Date: 2003-07-31

Engineering Change Order – Class I

ORIENTATION OF BEAM SCREENS IN THE CRYOMAGNETS OF THE LSS

Figure 1. The definition of orientation of the beam-screen.

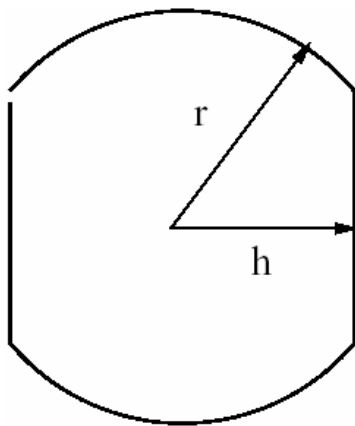
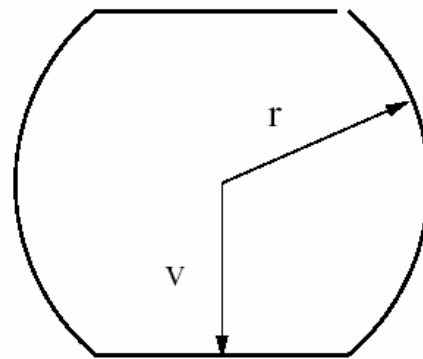
All the originally foreseen beam screens were oriented according to Fig 1B (V-type orientation). After a decision was made to install a beam-screen in every cold section [1], geometrical aperture studies have shown that another orientation was mandatory in many magnets in order to satisfy the aperture specification [2,3,4,5]. The final result of this analysis was reported in the form of a table, which was first published in a Functional Specification [6]. This table is copied here as Table 1.

The impact discussed here is related to the cryogenic system. The main issue is a new routing of the extremity of the cooling capillaries of the beam screen. With the V-type orientation, the capillary is simply curved by 90 degrees in the horizontal plane, in order to be connected to the helium network. For the new H-type beam screen, different solutions may be applied depending on the specific cases [8].
